SIGAR 21-30 Inspection Report

Kandahar Solar Power Plant: Project Was Generally Completed According to Contract Requirements

Photo 10 - Boundary Wall and Foundation

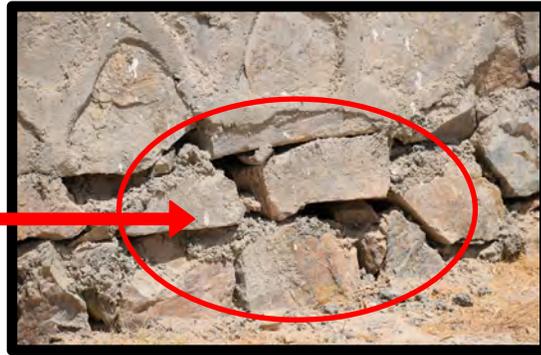
During our site visit, we found three maintenance issues at the solar power plant. Specifically, we found that 17 of the 36 security cameras (47 percent) were nonfunctional. We also found cracks in facility's boundary wall and on the roof of the control building (see photos 8 and 9). Further, we found mortar missing from stones that form the boundary wall's foundation (see photos 10 and 11). These were not identified during the project's final inspection in December 2019. While they do not affect the solar power plant's ability to operate as intended and produce electricity, the issues indicate Dynasty's difficulty in properly maintaining the plant.
